Sonoma County Board of Supervisors

June 6, 2023

PLP22-0009 (19675 7th St E)

Zone Change and Certificate of Modification

Site Map
Lands of Locke

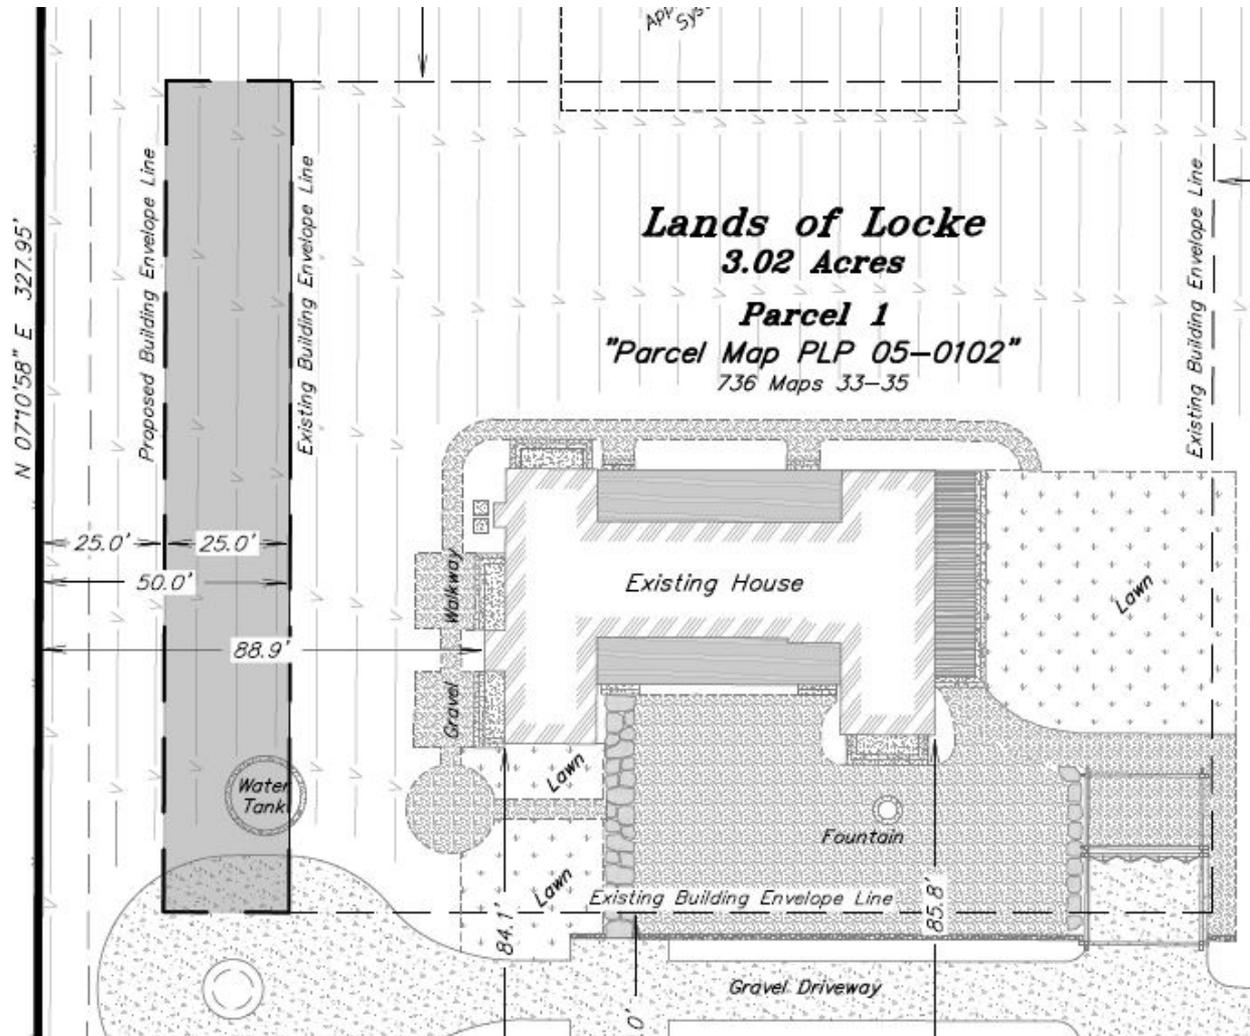
Certificate of Modification: Building Envelope Expansion

Local Agency Request Parcel Map

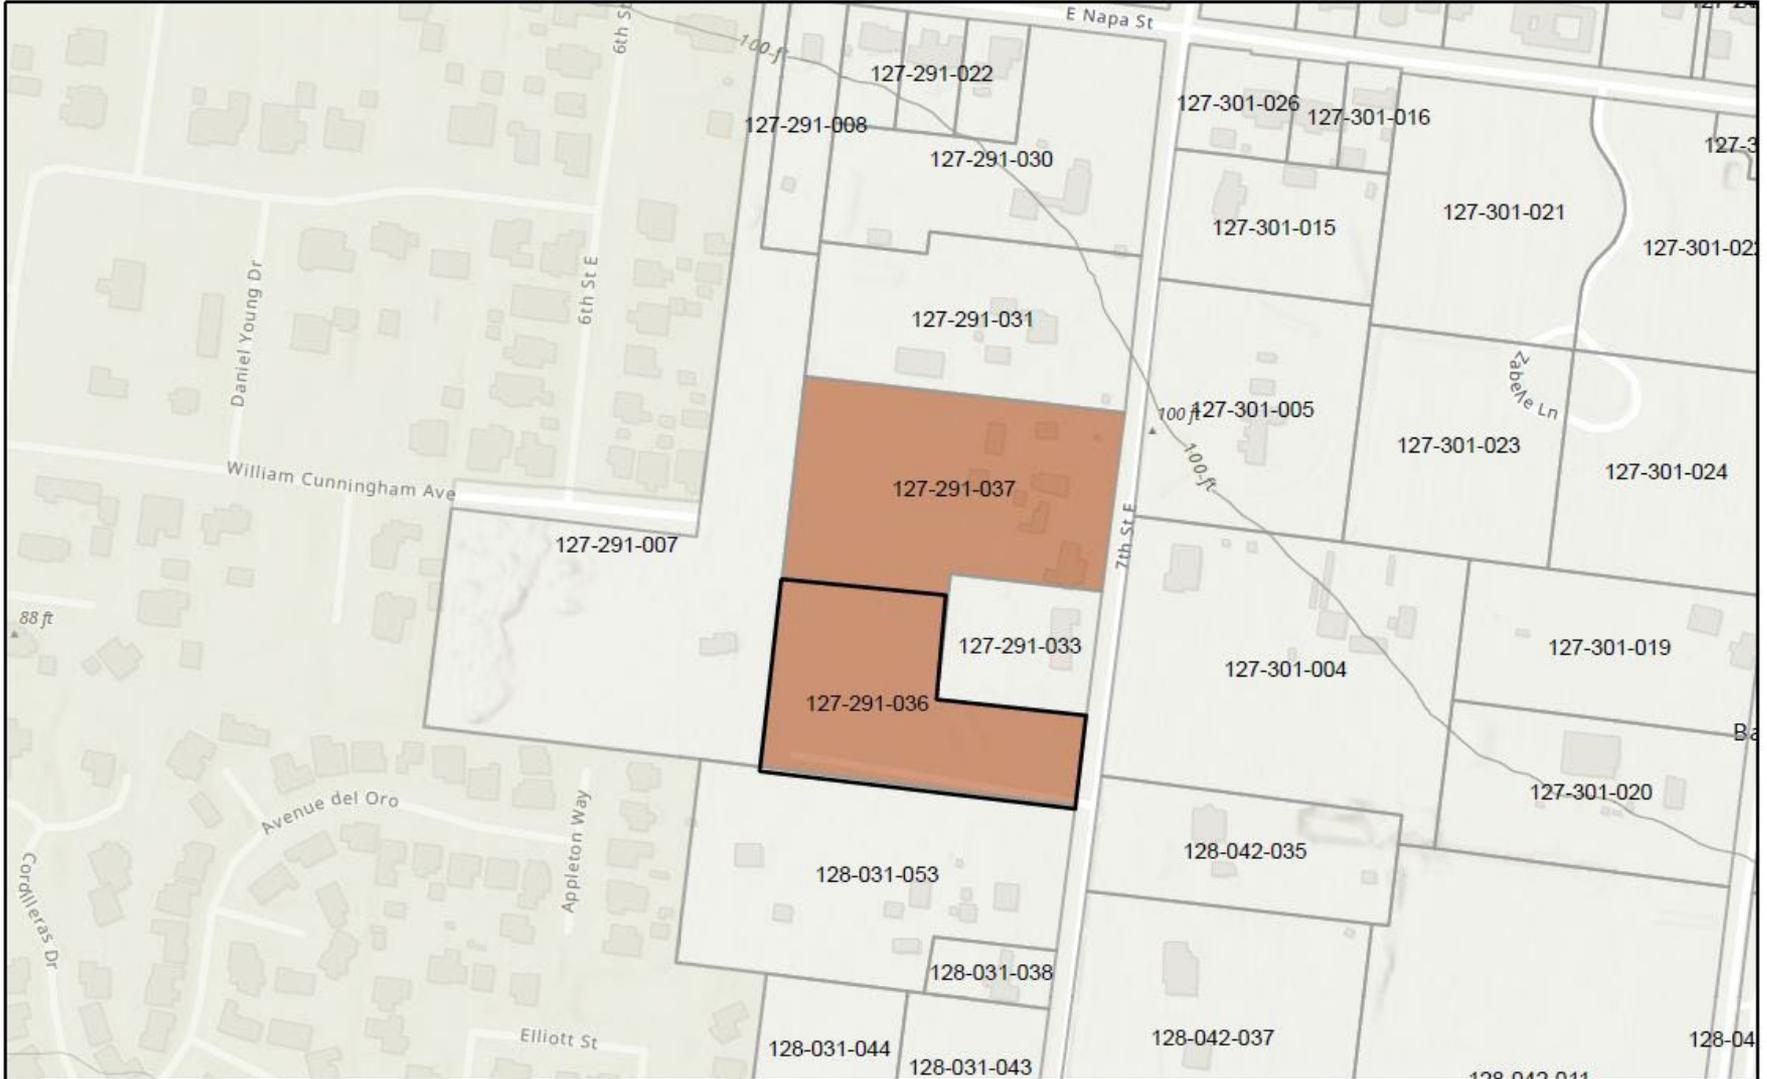
Certificate of Modification: Revising Note 15

Existing: "No second units shall be allowed on these lots."

Proposed: "No second unit shall be allowed on these lots, except for Parcel 1.
